## THE RANCH SKETCH PLAN

### LETTER OF INTENT

DECEMBER 2018, *REVISED MAY 2019*

Figure 7: Extract from the County Parks Master Plan

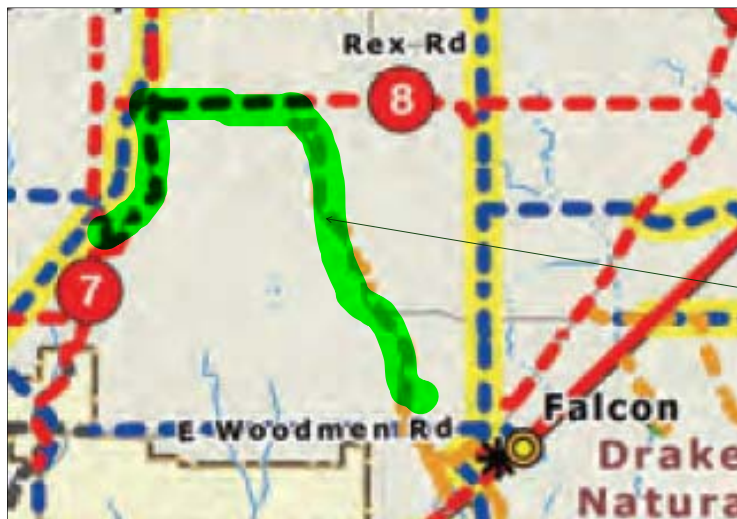
show the ranch prop  
boundary; if the trail  
runs south of  
woodmen; show the  
connections thru the  
property or use  
leaders and label

The Ranch Visual Analysis

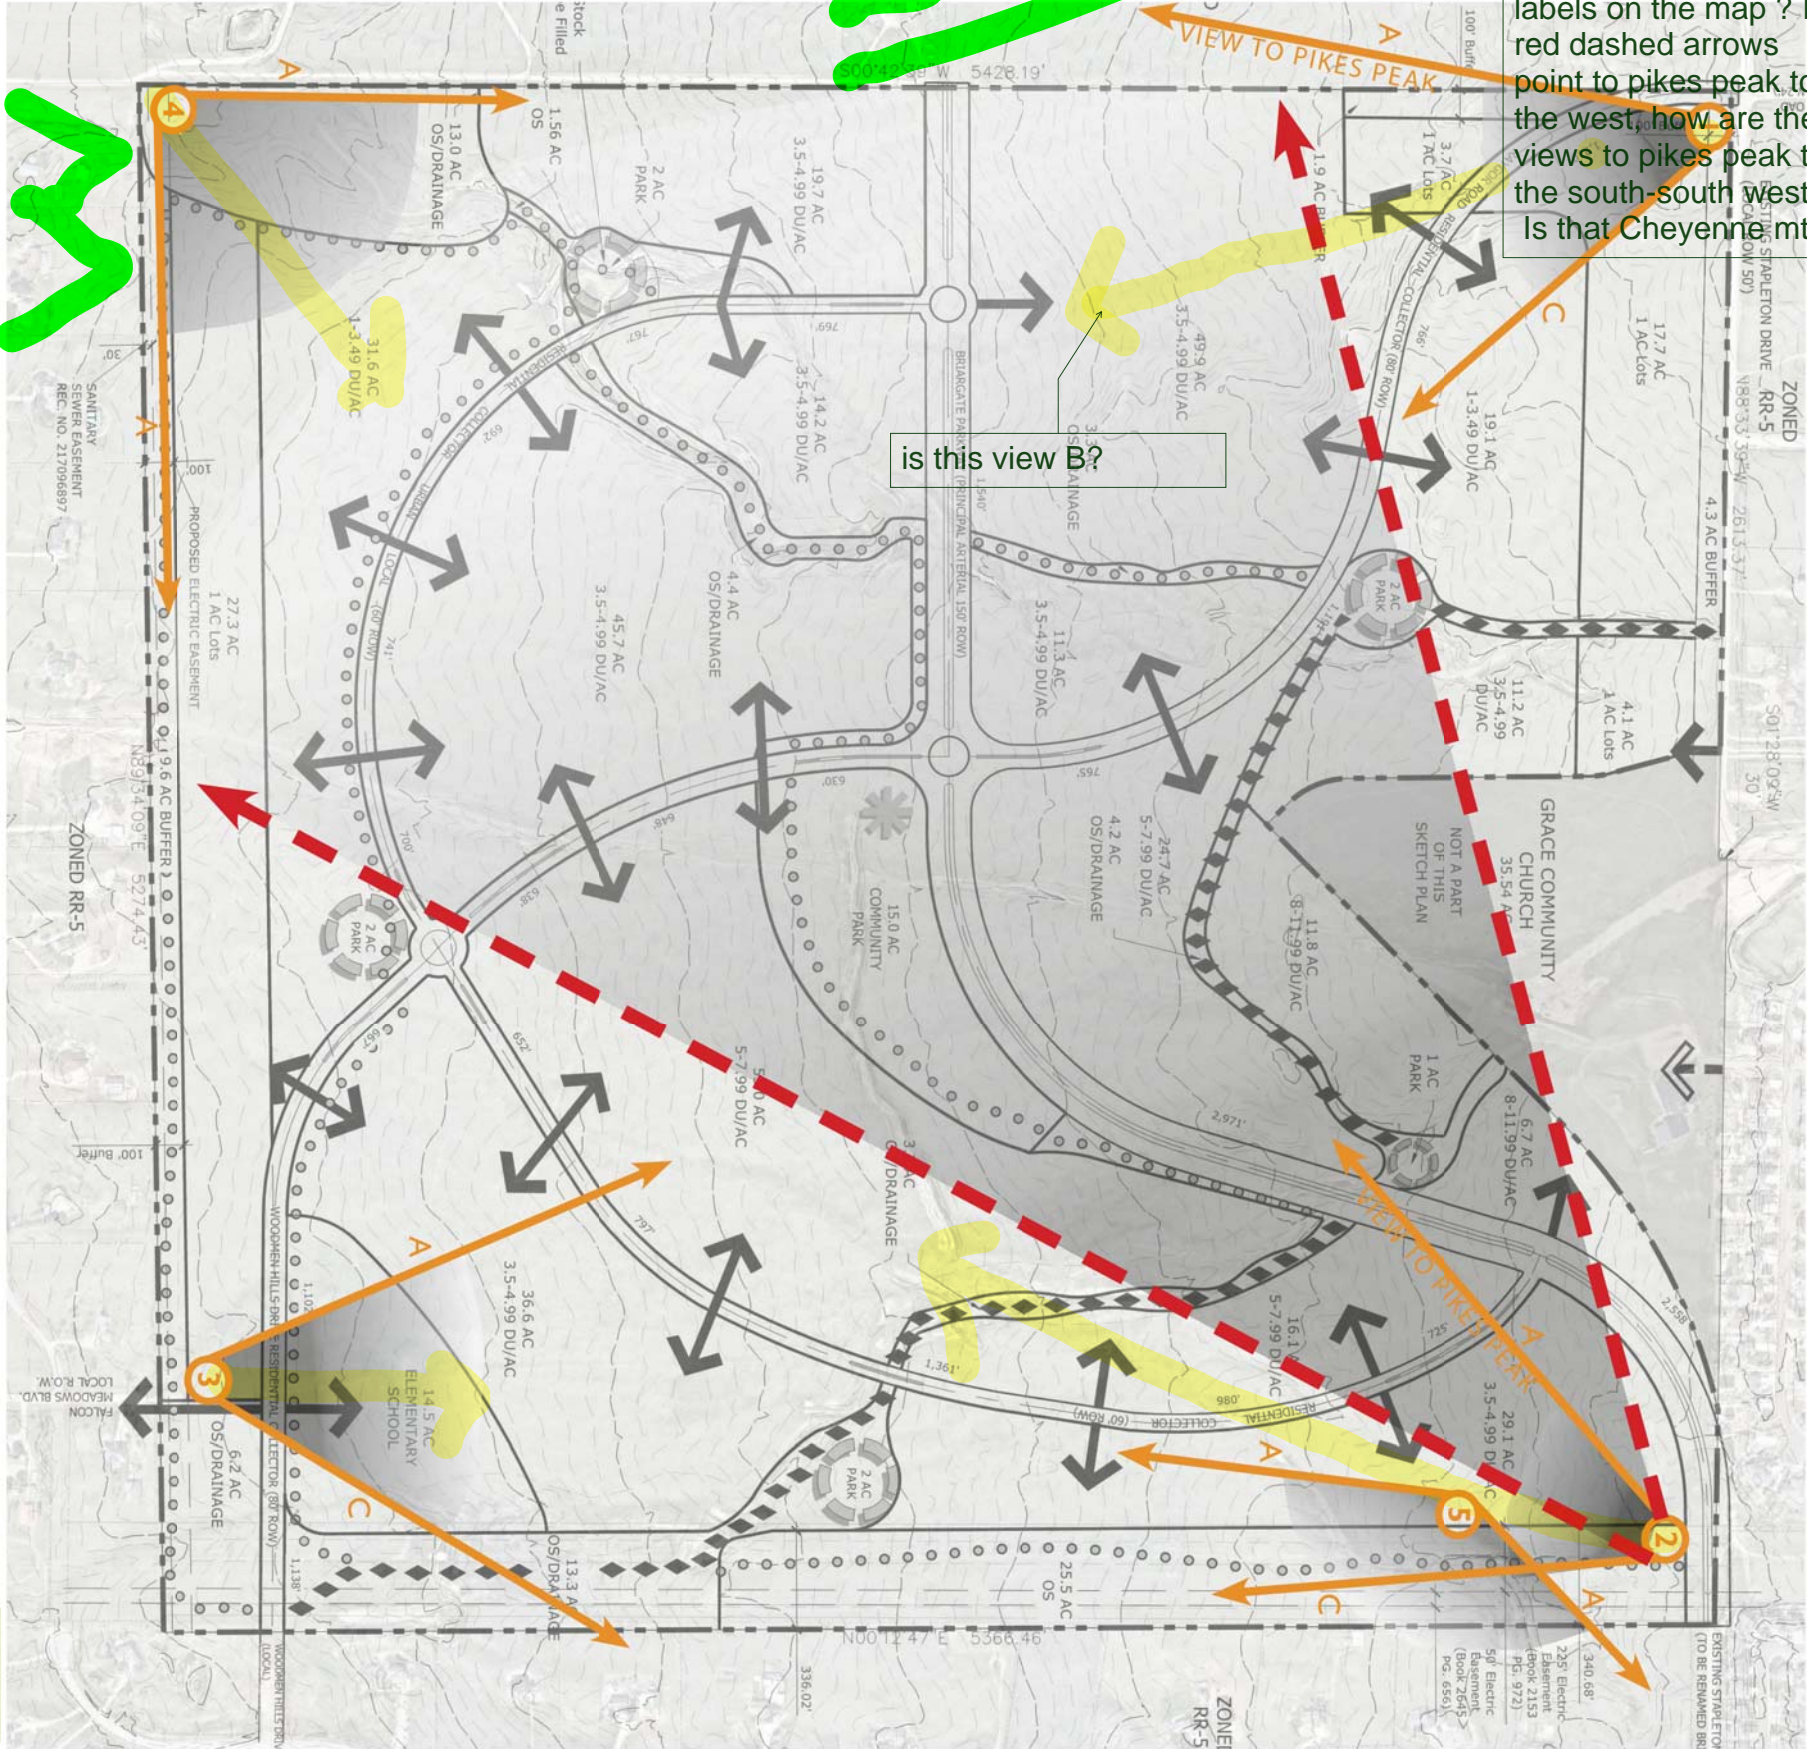
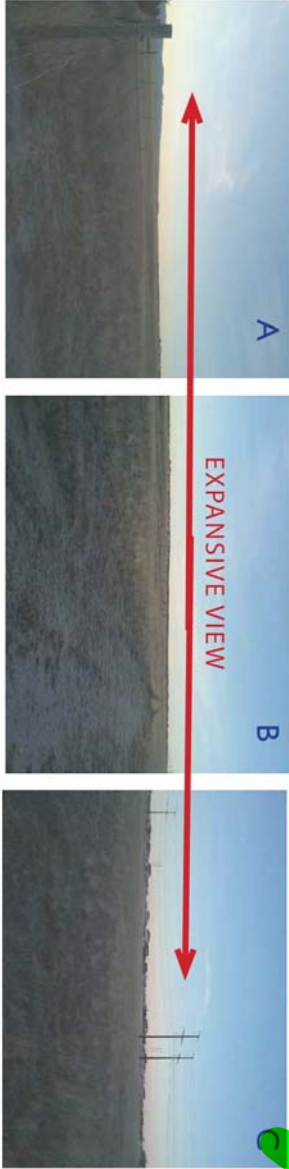
something is off here...where is B labels on the map ? If red dashed arrows point to pikes peak to the west, how are the views to pikes peak to the south-south west? Is that Cheyenne mt?

is this view B?
